**Amendments to the Drawings:**

### **REMARKS**

Appl. No. 10/661,808  
Amdt. Dated July 18, 2006  
Reply to Office Action of March 29, 2006  
Annotated Sheet Showing Changes

FIG. 1 (PRIOR ART)

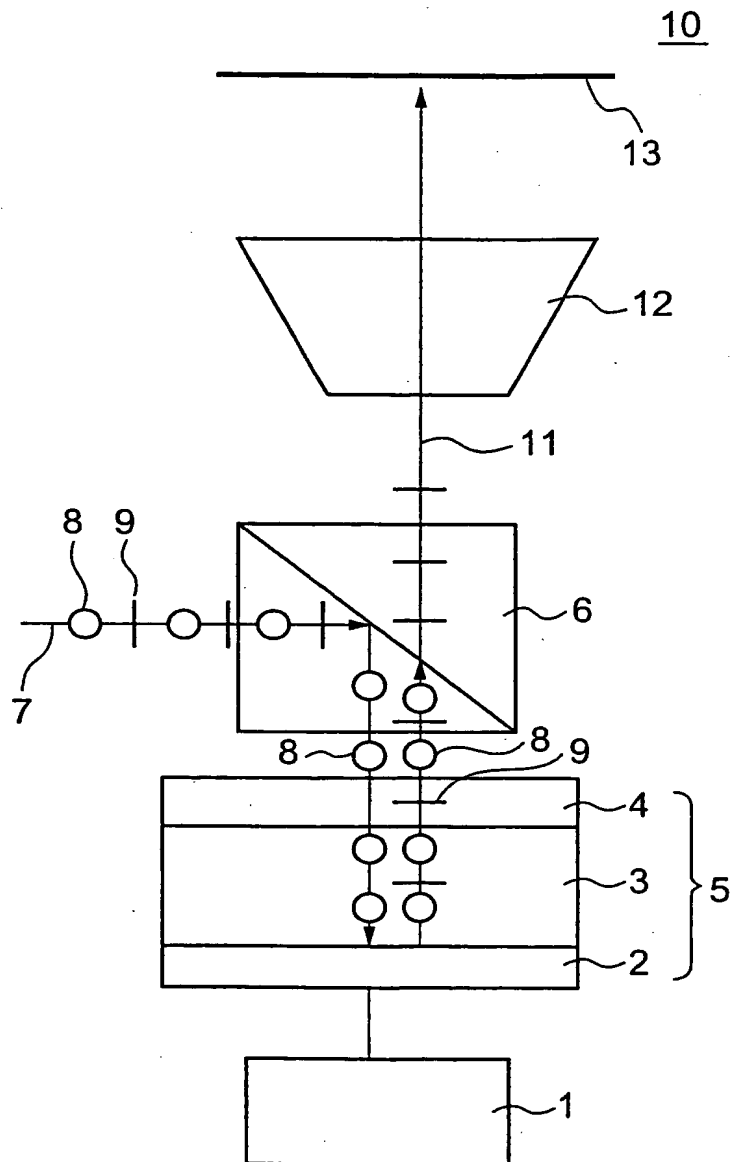
The drawing have been objected as failing to provide the legend of –Prior Art – to indicate the conventional art.

It is respectfully submitted that the Figs. 1 – 9 have been amended to provide the legend of –Prior Art – to indicate the conventional art. It is respectfully submitted that there is sufficient support for the amended Figs. 1 – 9 in the specification, especially the descriptions at page 8, lines 16 – 36 of the specification.
